PIC16C62B Rev. A Silicon Errata Sheet

The PIC16C62B (Rev. A) parts you have received conform functionally to the Device Data Sheet (DS35008A), except for the anomalies described below.

FIGURE 1: $\overline{\text{MCLR}}$ EXTERNAL CIRCUIT

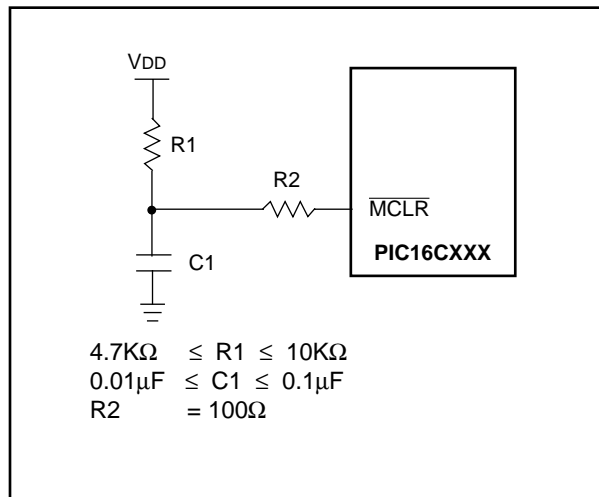
The minimum specification for the $\overline{\text{MCLR}}$ must be met in order to RESET the PIC16CXXX. If a $\overline{\text{MCLR}}$ pulse occurs that is less than the minimum specification (parameter #30), improper device operation can occur.

If the Minimum specification cannot be met, then an external circuit must be used to insure that any pulse width less than the specification will be filtered before it reaches the $\overline{\text{MCLR}}$ pin.

A possible circuit is shown in Figure 1. Proper design validation needs to be done to ensure desired operation over the applications operating conditions

Figure 1: Wake-up from Sleep

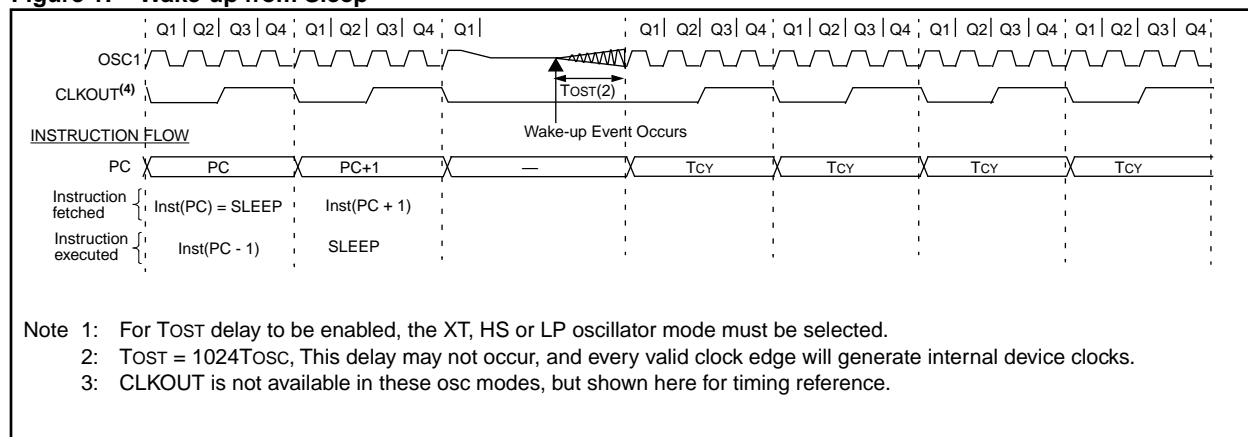
The Oscillator Start-up Timer (TOST) delay may not occur when the device wakes-up from sleep.

Figure 1 shows the start-up of the crystal after the event that causes the device to wake up from sleep mode (as specified in device data sheet). The start-up time (TOST) may not occur.

In applications where time based measurements are started immediately after wake-up from sleep, the suggested work around should be implemented.

After the SLEEP instruction, do a software delay of 256 Tcy (same as 1024 TOSC). At the Reset and Interrupt vector addresses, test to see if the device woke from sleep (the $\overline{\text{TO}}$ and $\overline{\text{PD}}$ bits), and if the device did wake from sleep, ensure that the total cycle delay is 256 Tcy.
